Appendix 2

Contract 42A - Dredging Operations, Revised Drawings

GENERAL ELECTRIC COMPANY • HUDSON RIVER PCBs SUPERFUND SITE
SEDIMENT REMEDIATION - PHASE 2 DREDGING PROJECT

CONTRACT 42A - DREDGING OPERATIONS

DREDGE AREA PLAN - RIVER MILE 188.9 - 188.5

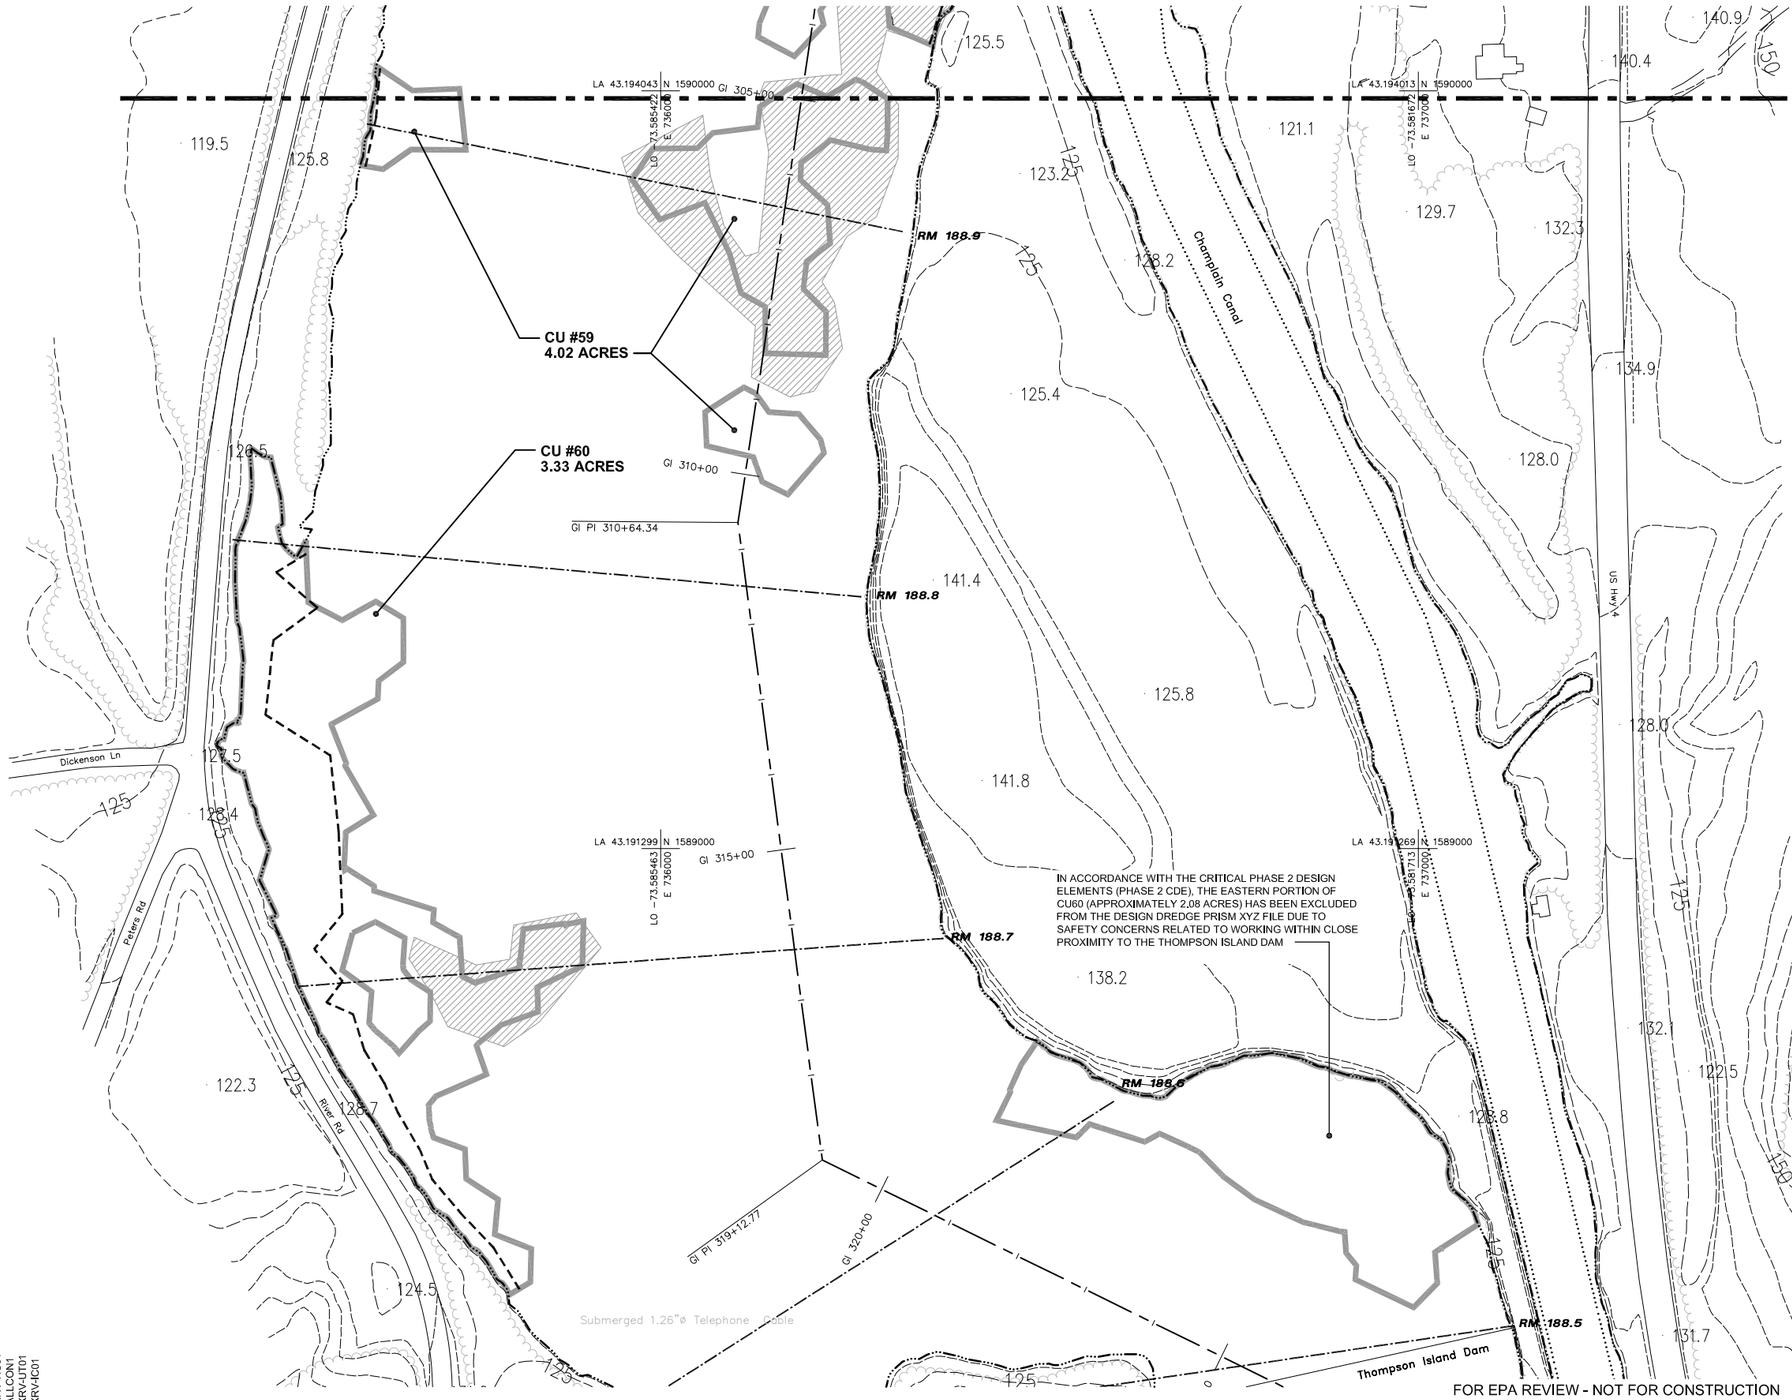
IN ACCORDANCE WITH THE CRITICAL PHASE 2 DESIGN ELEMENTS (PHASE 2 CDE), THE EASTERN PORTION OF CU60 (APPROXIMATELY 2.08 ACRES) HAS BEEN EXCLUDED FROM THE DESIGN DREDGE PRISM XYZ FILE DUE TO SAFETY CONCERNS RELATED TO WORKING WITHIN CLOSE PROXIMITY TO THE THOMPSON ISLAND DAM
